**ON-SITE SEWAGE DISPOSAL SYSTEM  
HOWARD COUNTY HEALTH DEPARTMENT  
BUREAU OF ENVIRONMENTAL HEALTH**

SUBDIVISION: Waterford Farms

LOT NUMBER: 29

A514952-A

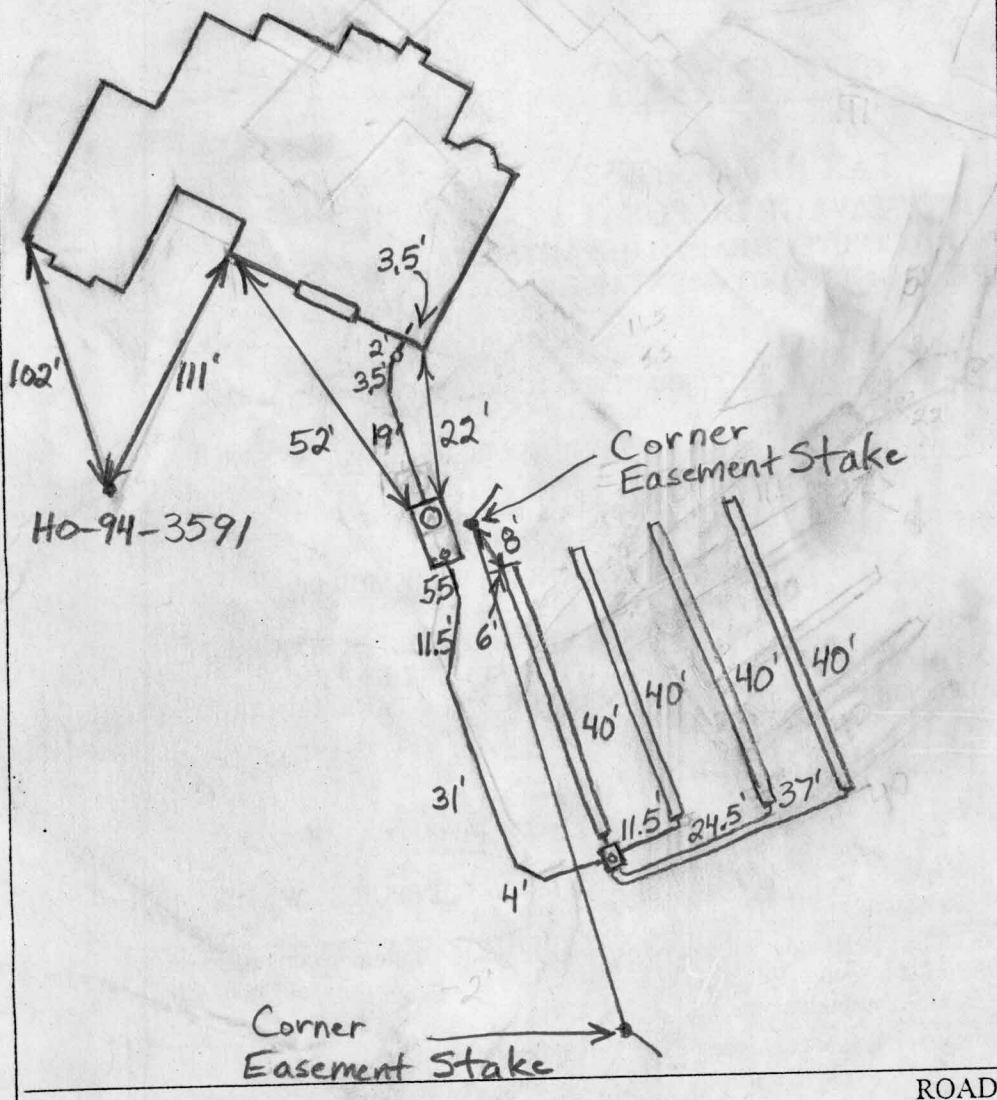
PRE-CONSTRUCTION 10/3/05 To install 4 short trenches across the top of the knoll. Keep on contour as best possible. Keep top of the knoll. Keep out of proposed grading around house. BB

INSTALLATION 10/5/05 Trenches installed across part of top of knoll. Inlet depth varies but trench bottoms are level per contractor. Why was system designed for 3 bedroom house? Need levelers in distribution box. BB 12/21/05 O.K. to set tank in side of hill if it has a traffic bearing lid. Keep tank out of drainage area as much as possible BB 12/22/05 Tank set and house connection made. O.K. to cover everything BB
